STATE OF VERMONT  
AGENCY OF TRANSPORTATION

PROJECT **CHESTER** PROJECT NO. **BRF 025-1(35)**

PROJECT: BRIDGE #12 VT 103-TH OVER WILLIAMS RIVER  
LOCATION: CHESTER, VERMONT  
ENGINEER: MCFARLAND-JOHNSON, INC.  
CUSTOMER: EASTERN BRIDGE LLC  
DRAWING TITLE: GENERAL NOTES  
DRAWN BY: D.B. 08/10/03 JOB  
CHECKED BY: L.D. 11/14/03 NUMBER: 4065 SHEET  
NUMBER: 084 54

**DECK BEARING DEVICE**  
 QUANTITY - 1  
 \* PLEASE VERIFY QUANTITY

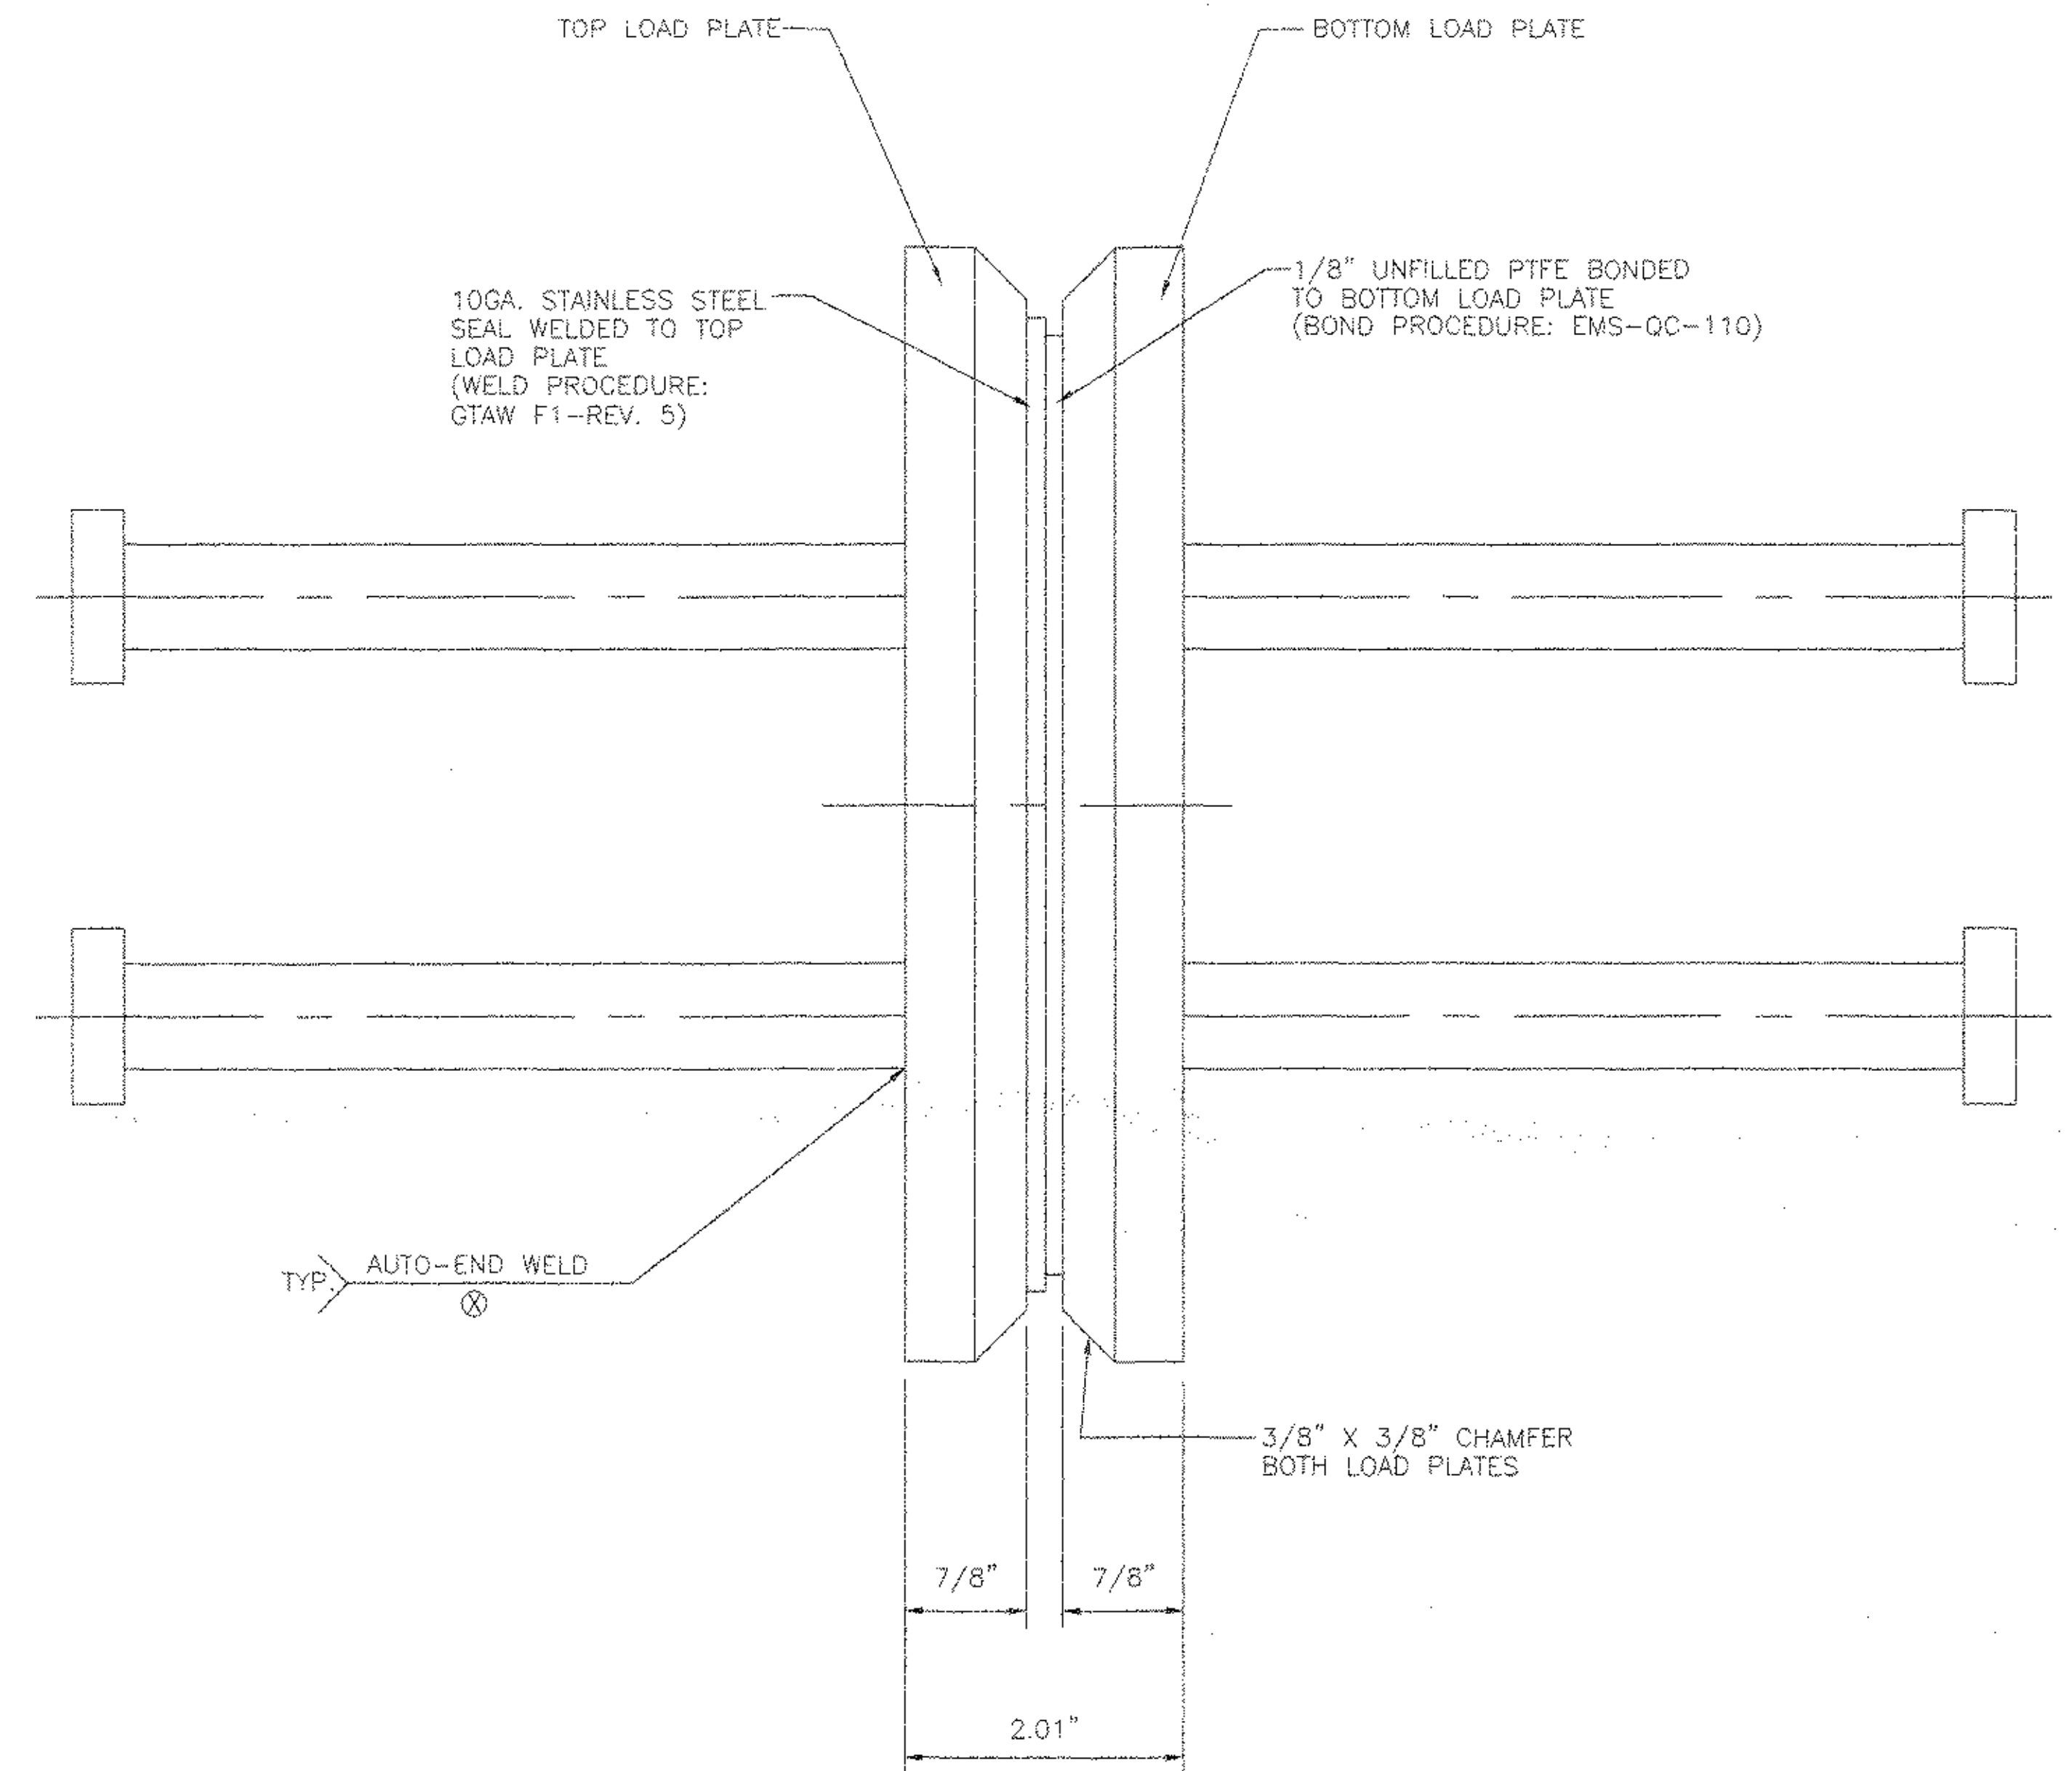
\*PLEASE VERIFY PTFE SIZE TO BEARING LOADS.
